Access Compliance Report Public Rights-of-Way (RR Crossings)

Intersection ID: 14235	Main Street: CAMDEN_RD	Location: N/A
ADA ID: 24368C243CF5	Overall Compliance: No	Severity Score: 0.0
Codes/Mitigation Info/Possible Solution		Field Measurements/Component Compliance

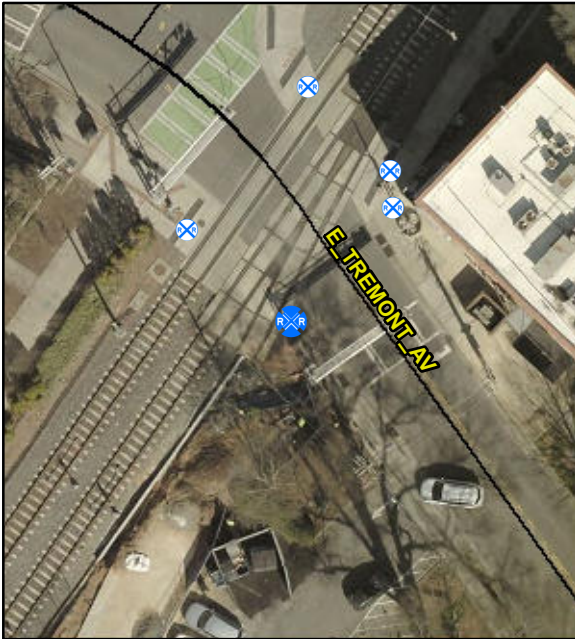
Compliance	Description	Data
Yes	DWS Provided?	Yes
Yes	DWS Contrast?	Yes
Yes	DWS Width (in)	Yes
Yes	DWS Length (in)	36.0
No	DWS Offset (in)	18.0
No	Pedestrian Gate?	No
N/A	DWS Outside Gate?	No
N/A	Rail Type?	LightRail
No	Flangeway Gap (in)	3.0
Yes	Sidewalk Width (in)	84.0

**Remove & Replace Detectable
Warning System. Provide Pedestrian
Gate. Remove & Replace Walking
Surface Adjacent to Rail.**
